Control Number: 35077

Re: Project No./Docket No. 35077 – Wind Energy Transmission Texas, LLC’s Generation Interconnection Agreement Filing Pursuant to PUCT Substantive Rule 25.195(e)

SECOND AMENDMENT TO GENERATION INTERCONNECTION AGREEMENT

Attachment 1 to Exhibit “C”

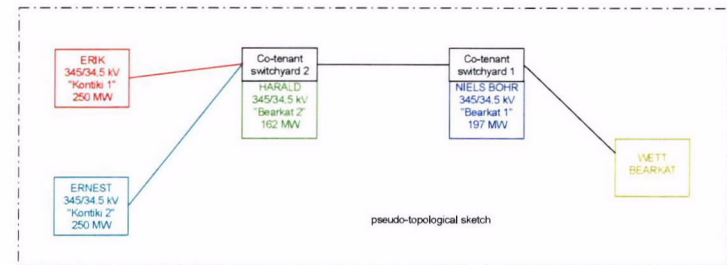
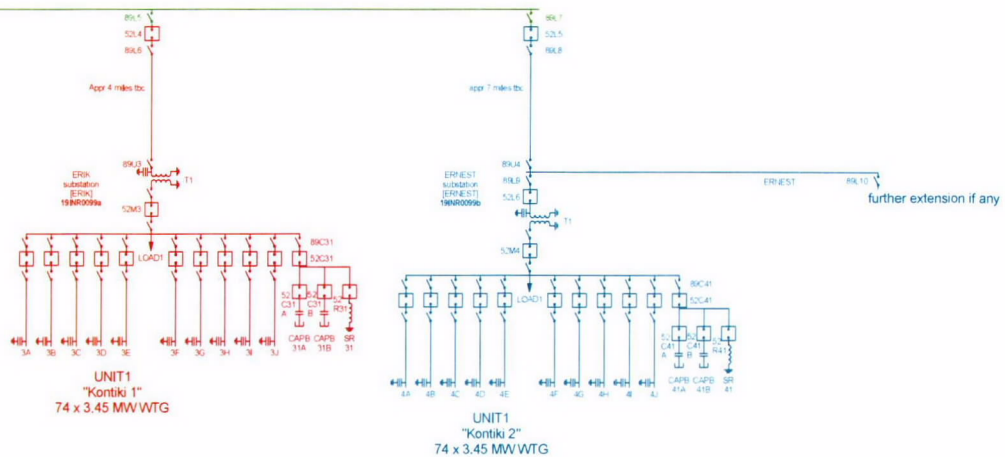
2. The definition of “Kontiki Switchyard” in Section 1.25 of the Amended GIA is hereby replaced in its entirety with the following definition:

1.25 “Kontiki Switchyard” shall be the GIF switchyards owned individually by Kontiki, as described in Exhibit “C” as the Kontiki I Switchyard and the Kontiki II Switchyard and collectively described as the Kontiki Switchyards.

3. The definition of “Kontiki Transmission Line” in Section 1.26 of the Amended GIA is hereby replaced in its entirety with the following definition:

1.26 “Kontiki Transmission Line” shall be the GIF transmission lines owned individually by Kontiki, as described in Exhibit “C” as the Kontiki I Transmission Line and the Kontiki II Transmission Line and collectively described as the Kontiki Transmission Lines.

6. Attachment 1 to Exhibit “C” One Line Diagram of the Amended GIA is hereby replaced in its entirety with the Attachment 1 to Exhibit “C” One Line Diagram attached to this Amendment.
